Masco Printing and Embroidery Ltd.

30th May 2022

Observations

West and South elevation

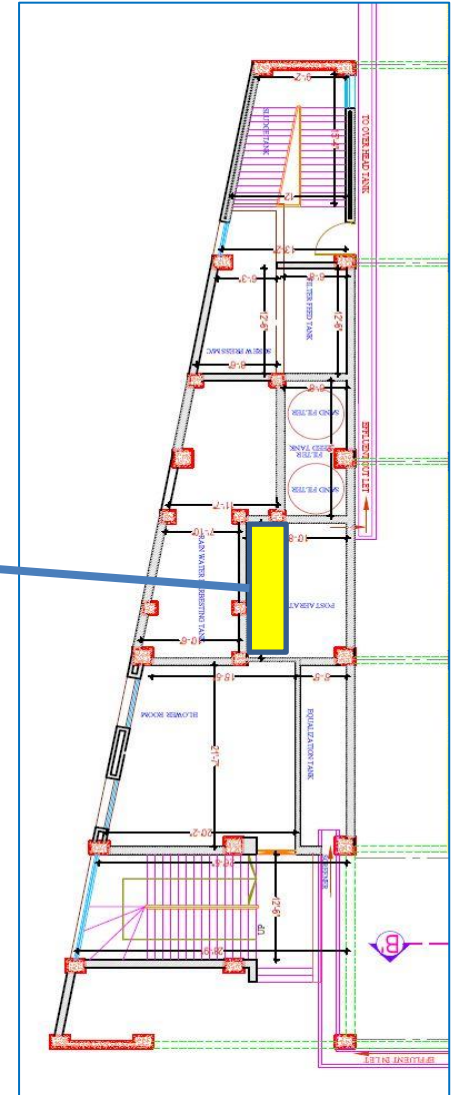
Design Report needs to be prepared

As per BNBC, every building or structure designed shall have its design documents prepared in accordance with the provision of Section 1.9.1. The design document shall include a design report, and a set of structural drawings, which shall be prepared in compliance with section 1.9.1.1 and section 1.9.1.2 as per BNBC. At the time of inspection, only as-built drawing was available, but no design report was available which is required to be prepared in compliance with section 1.9.1.1 (part-6, BNBC).

Masonry
Brick Pier
observed
on-site.

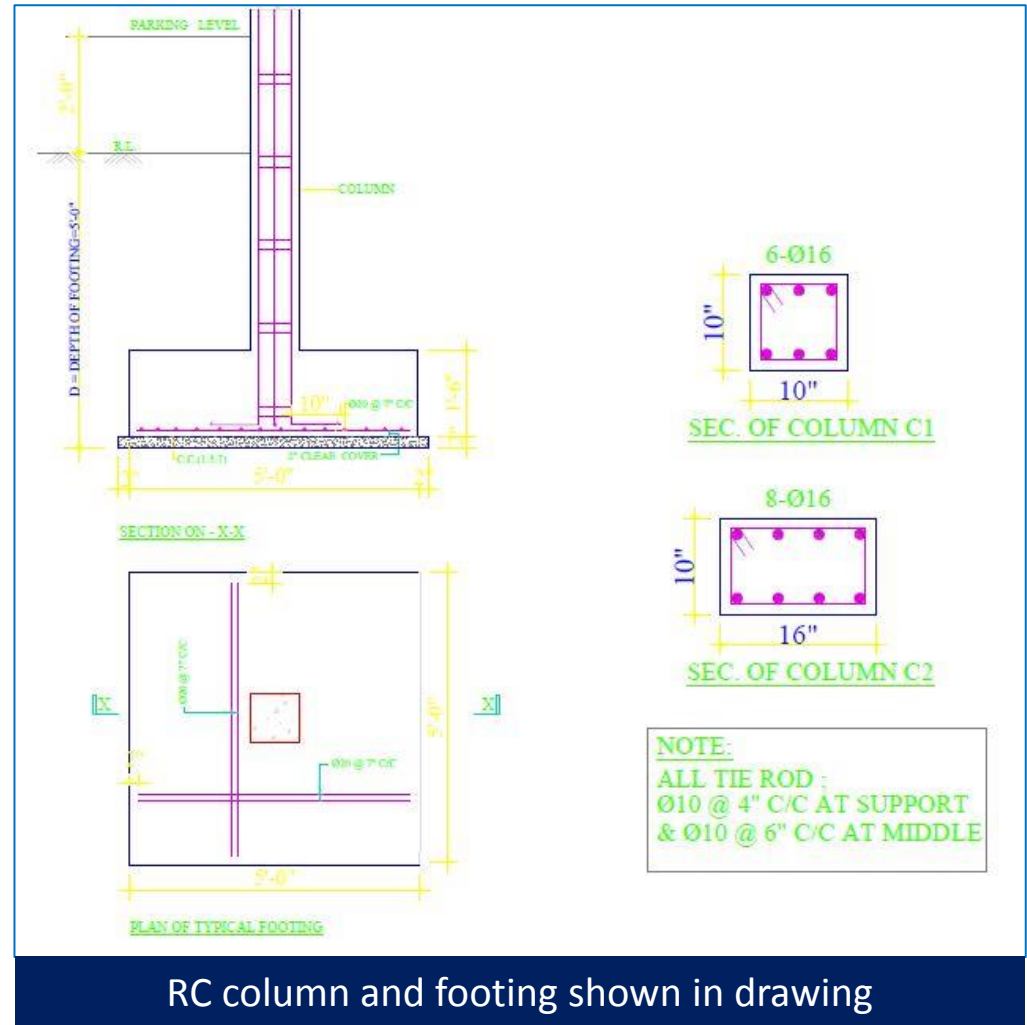
Mismatch in as-built drawing

As per structural drawing, the Security Building is made of RC column but during on-site verification RC column was not found. The building is made of masonry brick wall. The building engineer to survey the structure and prepare as-built structural drawings.
